HOLLYWOOD FARMHOUSE

CO16 9AP

Solar company's renewer's comments on possible siting of panels on the ground.

Potential Ground mount system:

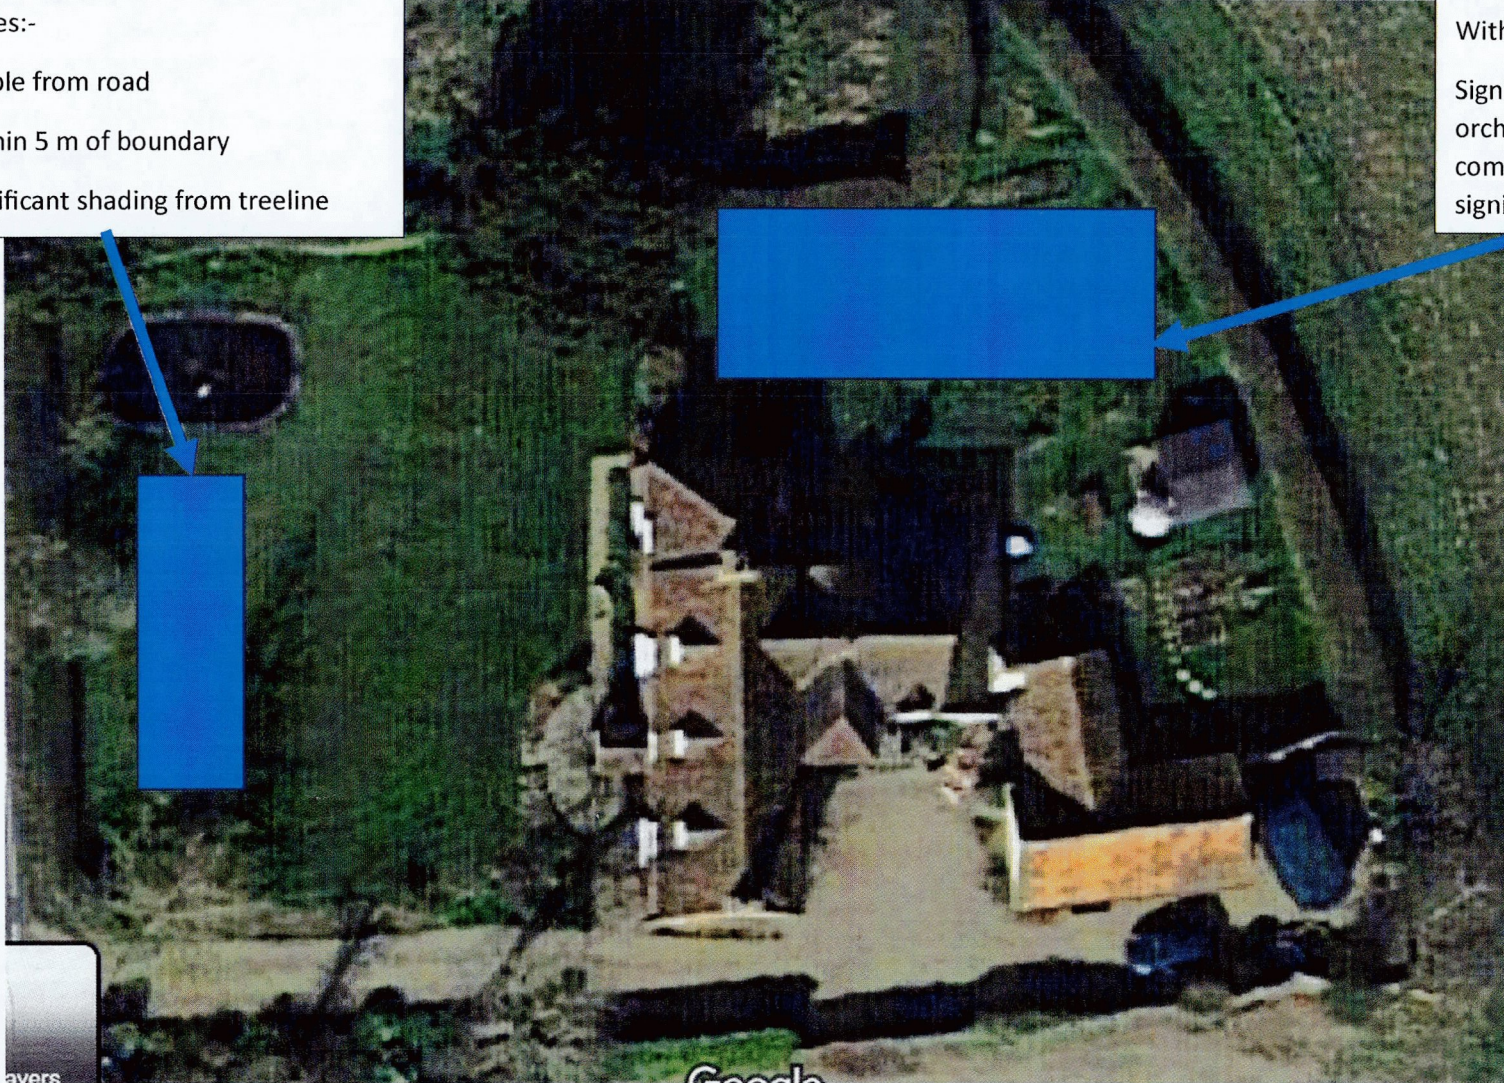
Issues:-

Visible from road

Within 5 m of boundary

Significant shading from treeline
